**IEEE P802.15**  
**Wireless Personal Area Networks**

Project	IEEE P802.15 Working Group for Wireless Personal Area Networks (WPANs)		
Title	<b>Proposed Resolution for MR-FSK Channel Parameters for the License-Exempt 902 - 928 MHz ISM Band</b>		
Date Submitted	[30 June, 2010]		
Source	[Steve Jillings] [Semtech Corporation] [address]	Voice: Fax: E-mail:	[+1 (805) 480-2196] [+1 (805) 498-3804] [sjillings@semtech.com]
Re:			
Abstract			
Purpose	Methods of defining the ACP or modulation bandwidth requirements of Clause 6 Table 1a		
Notice	This document has been prepared to assist the IEEE P802.15. It is offered as a basis for discussion and is not binding on the contributing individual(s) or organization(s). The material in this document is subject to change in form and content after further study. The contributor(s) reserve(s) the right to add, amend or withdraw material contained herein.		
Release	The contributor acknowledges and accepts that this contribution becomes the property of IEEE and may be made publicly available by P802.15.

Figure 1: Measurement of Adjacent Channel Attenuation to FCC DA 00-705 at +14 dBm Output Power

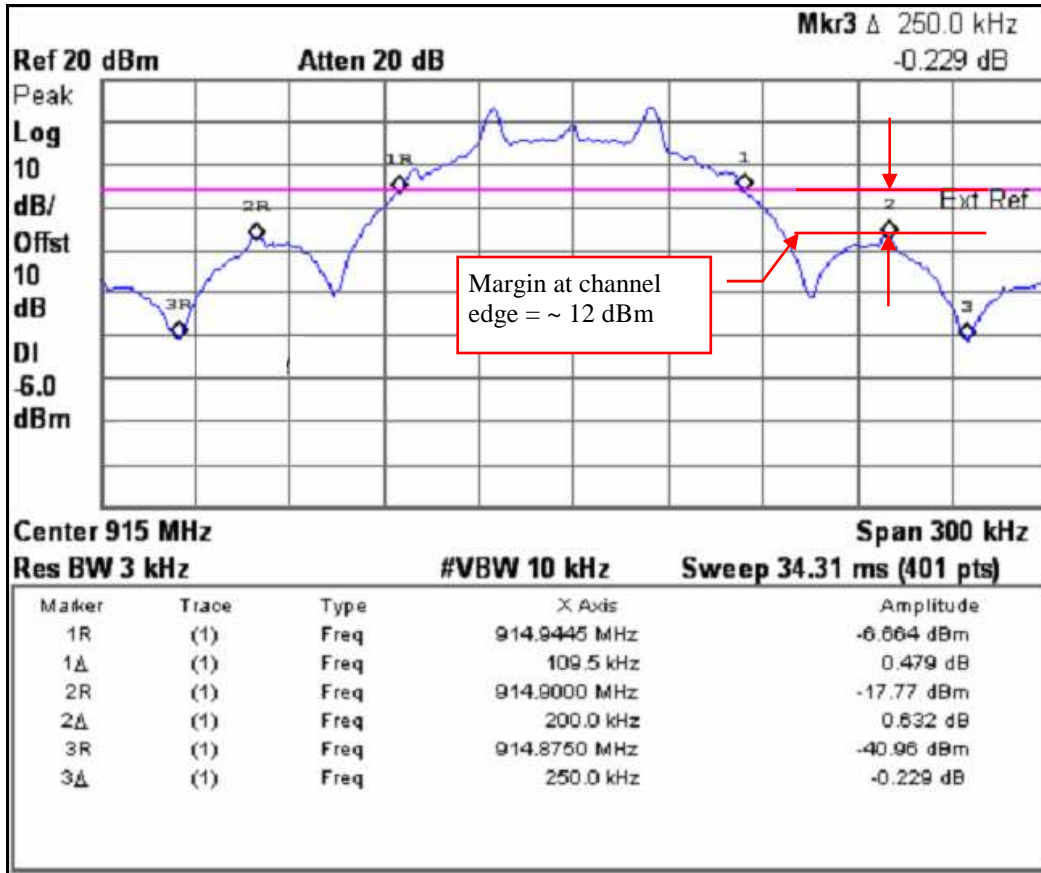
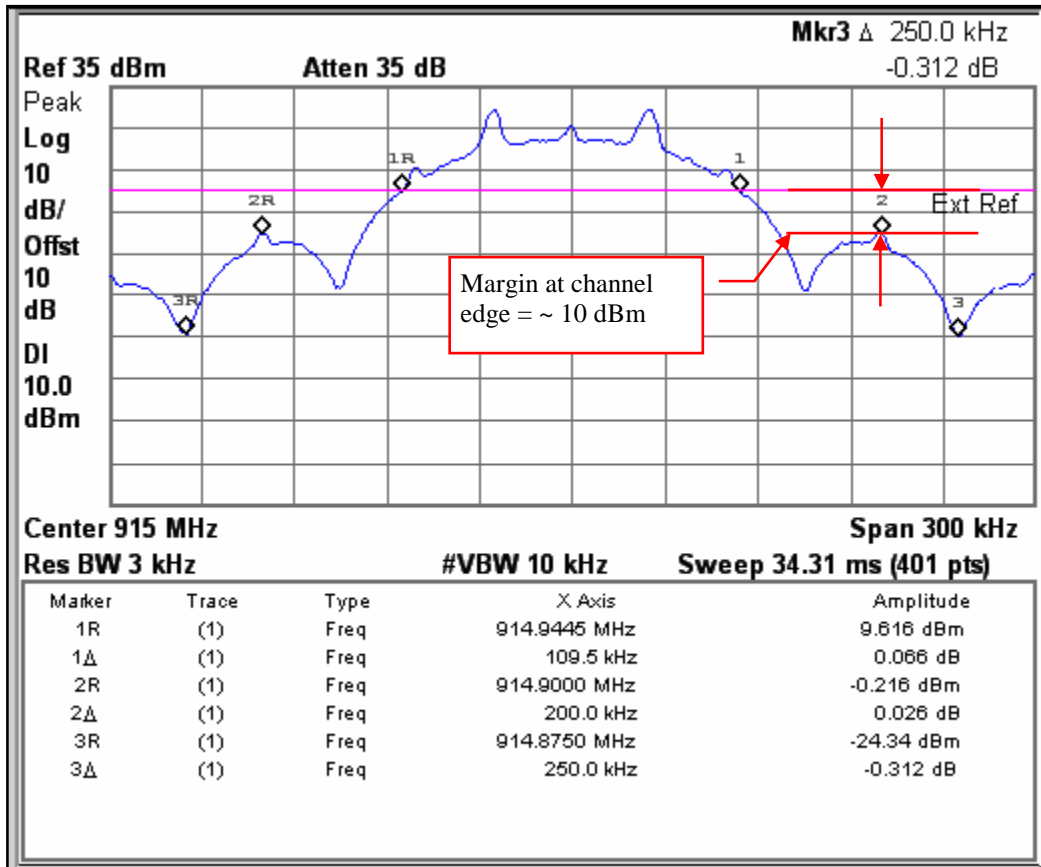
Figure 1 and Figure 2 illustrates that for FSK modulation, the adjacent channel attenuation for both condition at  $\pm 100$  kHz from the channel center frequency exceeds the 20 dB adjacent channel attenuation figure by a margin of typically 10 dB.

Note that the addition of an external PA reduces the margin by ~ 2 dB compared to the +14 dBm power setting due to the NF associated with the PA and attenuation setting of the spectrum analyzer.

Figure 3: Measurement of Modulation Bandwidth to ETSI EN 300 220-1 at +14 dBm Output Power

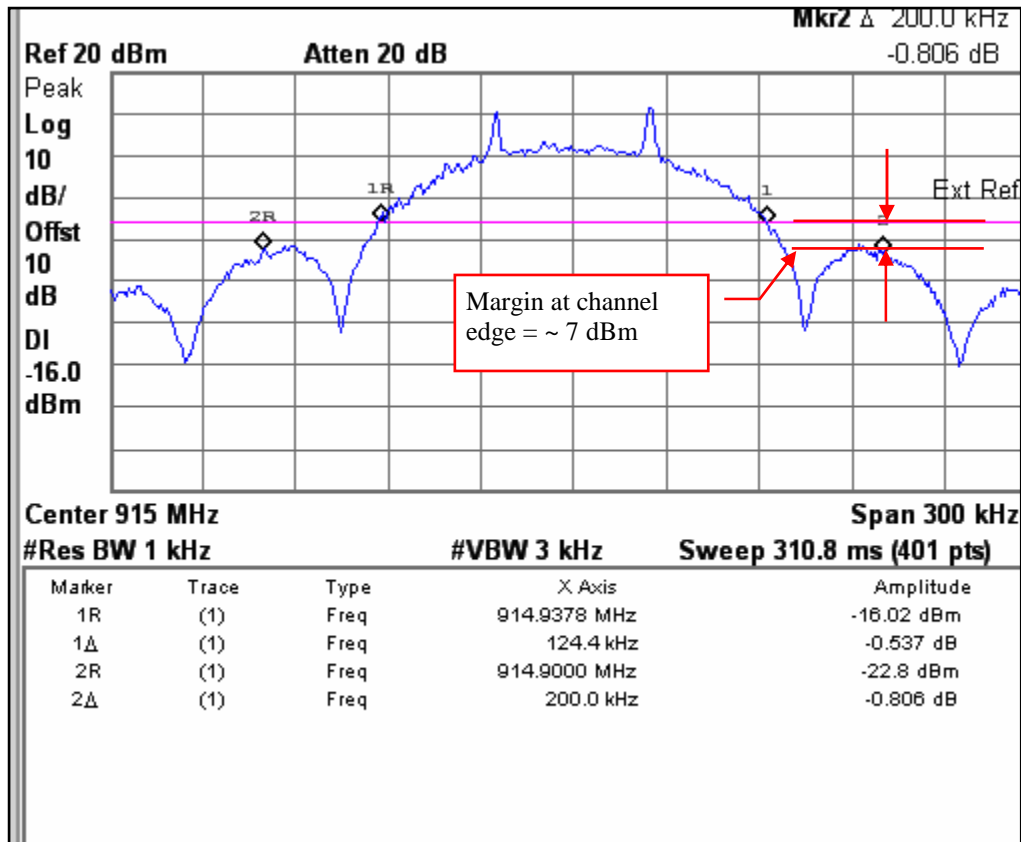
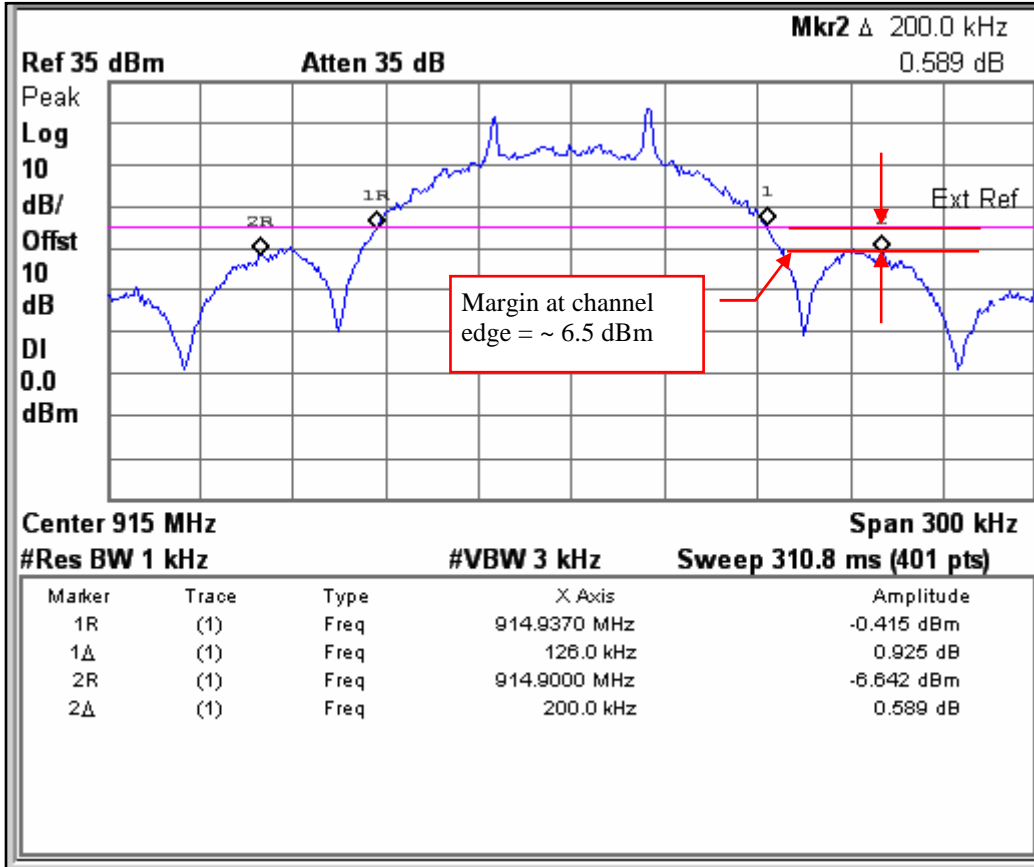
Figure 3 and Figure 4 illustrates that for FSK modulation, the adjacent channel attenuation for both condition at  $\pm 100$  kHz from the channel center frequency exceeds arbitrary 30 dB adjacent channel attenuation figure by a margin of typically 7 dB.

Note that the addition of an external PA reduces the margin by  $\sim 0.5$  dB compared to the +14 dBm power setting due to the NF associated with the PA and attenuation setting of the spectrum analyzer.

Figure 5: Interpretation of Comment Resolutions #360 - #364 at +14 dBm Output Power

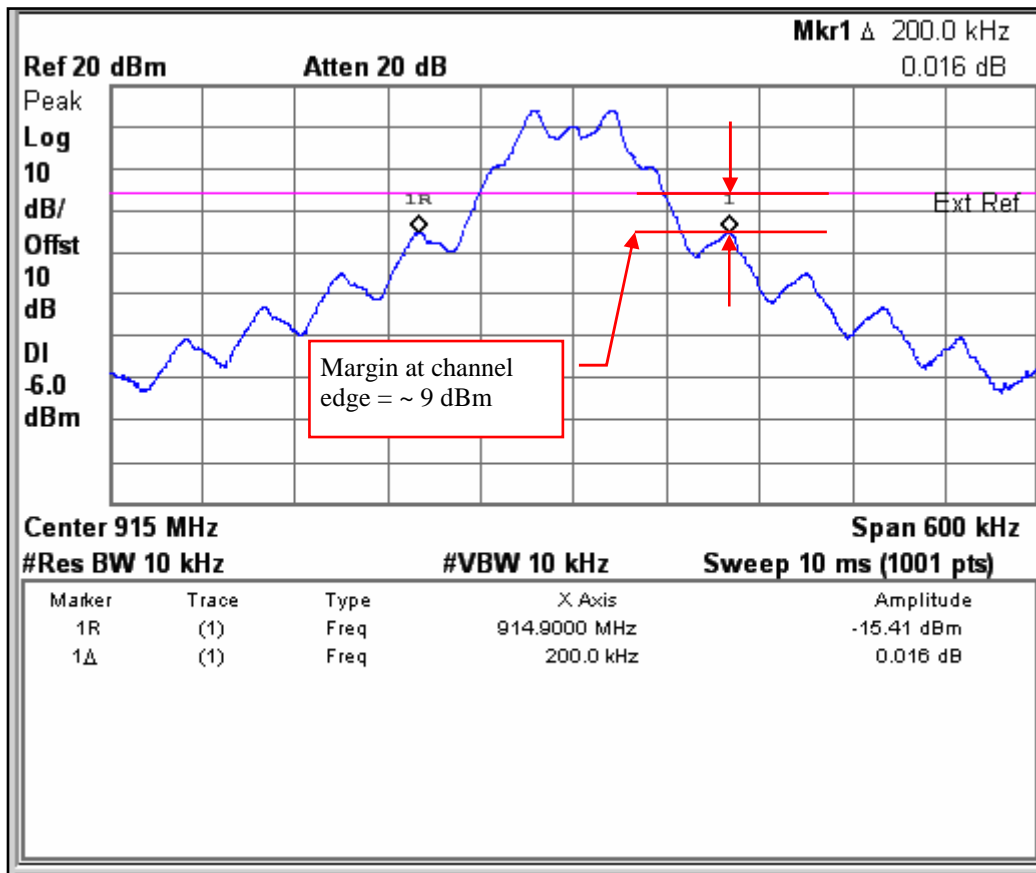
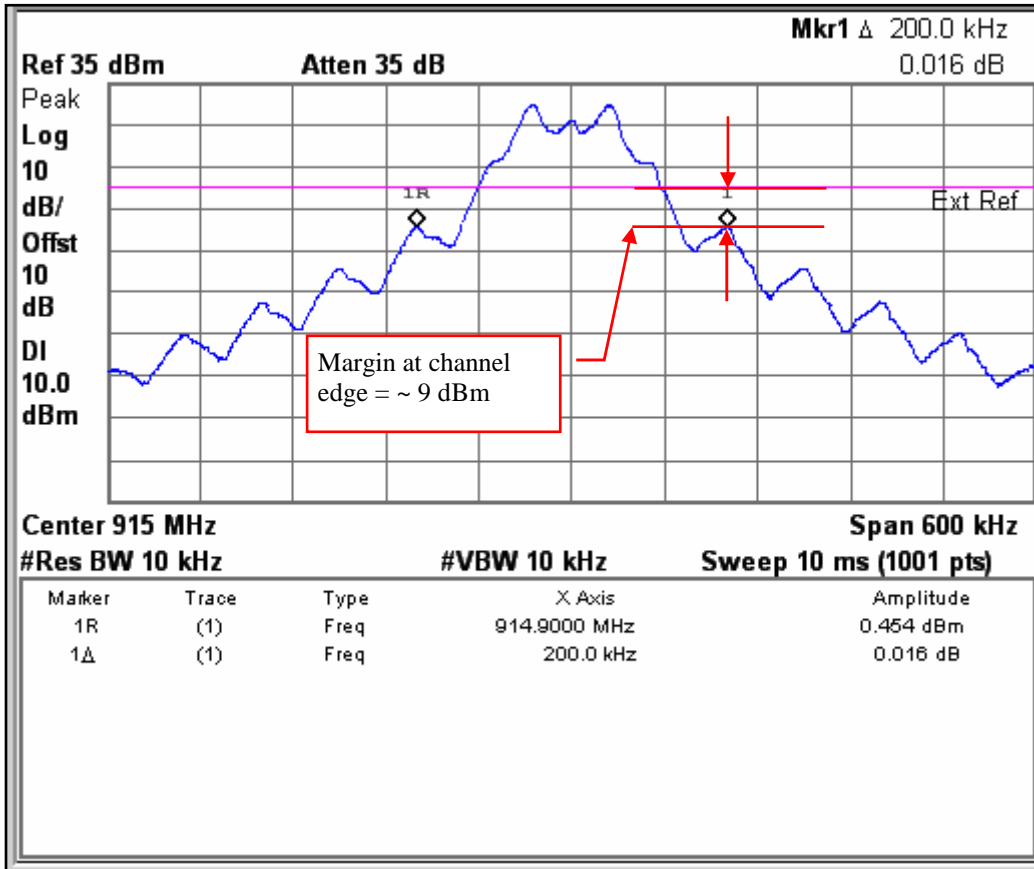
The display line indicated by is the -20 dB attenuation limit describe above. At the channel edges the 20 dB limit can be met by 2-FSK modulation with approximately 9 dB margin.
